FINITE ELEMENT SOLUTION OF SAINT-VENANT EQUATIONS^b

Discussion by Danny L. Fread,³ M. ASCE

FIG. 7.—Typical Single-Value and Loop Rating Curves

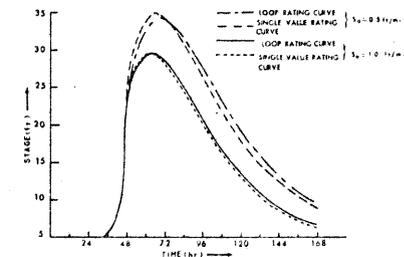
on the rising limb of the stage hydrograph, the finite element solution using 12-hr time steps exceeds that of the finite difference solution using 12-hr time steps and, on the falling limb, the relationship is reversed. This relationship is identical to that which would result when using the two different boundary conditions, as indicated in Fig. 7 by the relative magnitudes of the stages, h_r , h_f , and h_{sv} , associated with the rising limb (loop rating), falling limb (loop rating), and single-value rating, respectively.

FIG. 8.—Effect of Channel Slope and Downstream Boundary Rating Curve on Computed Downstream Hydrographs

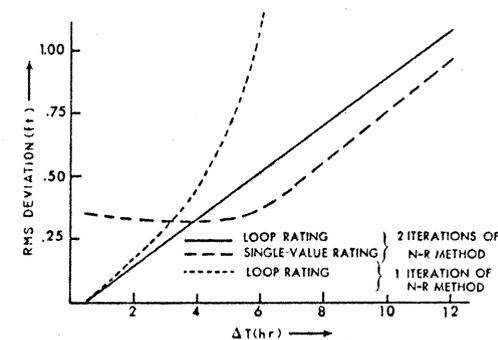
rate of change of the hydrograph. For the particular hydrograph examined by the authors, which has a time to peak of 48 hr and a 0.5-hr time step, the root mean square deviation between the two hydrographs (see Fig. 8) is 0.358 ft (0.109 m) when the channel bottom slope, S_o , is 1.0 ft/mile (0.0001894 ft/ft); however, when the bottom slope is reduced to 0.5 ft/mile (0.0000947 ft/ft), the root mean square deviation increases to 1.002 ft (0.306 m). A more complete presentation of the effects of slope and rate of change of flow on hydrographs determined from single-value and loop rating curves is given by the writer (22, pp. 30-35).
